Access Compliance Report

Public Rights-of-Way

Intersection ID: 2761	Main Street: BEAUVISTA_DR	Cross Street: MAPLE_COVE_LN	Location: SE
ADA ID: C94676826A0A	Ramp Type: PerpDiag	Initial Pass/Fail: Fail	Overall Compliance: No
Severity Score: 13.75			
Codes/Mitigation Info/Possible Solution		Field Measurements/Component Compliance

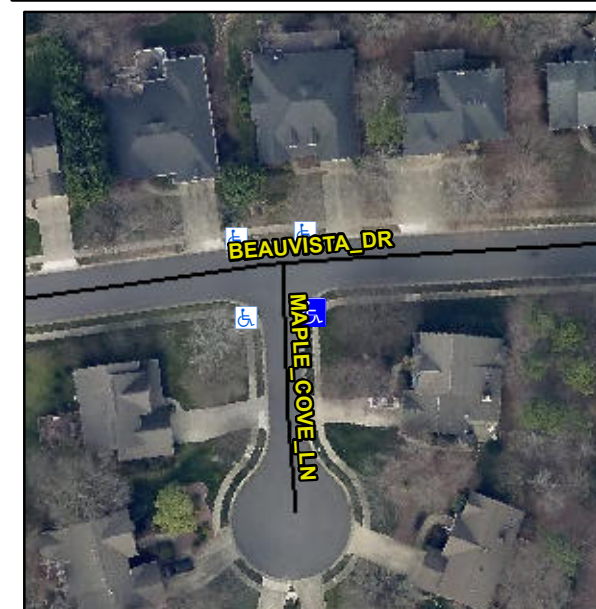
Not Found, R304.2.2, R304.5.3

Compliance	Description	Data	Compliance	Description	Data
N/A	Ramp Length (in)	50.5	No	Ramp Slope (%)	10.8
Yes	Ramp Width (in)	52.0	No	Ramp XSlope (%)	2.4
N/A	Flare Type LT	N/A	N/A	Flare Type RT	N/A
N/A	Flare Slope LT (%)	N/A	N/A	Flare Slope RT (%)	N/A
N/A	Flare Traversable LT?	N/A	N/A	Flare Traversable RT?	N/A
N/A	Landing Length (in)	N/A	N/A	DWS Provided?	N/A
N/A	Landing Width (in)	N/A	N/A	DWS Contrast?	N/A
N/A	Landing Slope (%)	N/A	N/A	DWS Length (in)	N/A
N/A	Landing X Slope (%)	N/A	N/A	DWS Full Width?	N/A
N/A	Landing Curb? (Y/N)	N/A	N/A	DWS Offset (in)	N/A
N/A	Shared Landing?	N/A			
N/A	Gutter Ponding?	N/A	N/A	Gutter Slope (%)	N/A
N/A	Gutter Lip Ht (in)	N/A	N/A	Gutter X Slope (%)	N/A
N/A	Painted X Walk1?	No	N/A	Painted X Walk2?	No
	X Walk 1 Direction	To N		X Walk 2 Direction	To W
N/A	X Walk 1 Width (in)	N/A	N/A	X Walk 2 Width (in)	N/A
	X Walk 1 Slope (%)	0.7		X Walk 2 Slope (%)	4.0
	X Walk 1 X Slope (%)	5.2		X Walk 2 X Slope (%)	3.8

Remove & Replace Curb Ramp With Two New Directional Ramps or Equivalent.
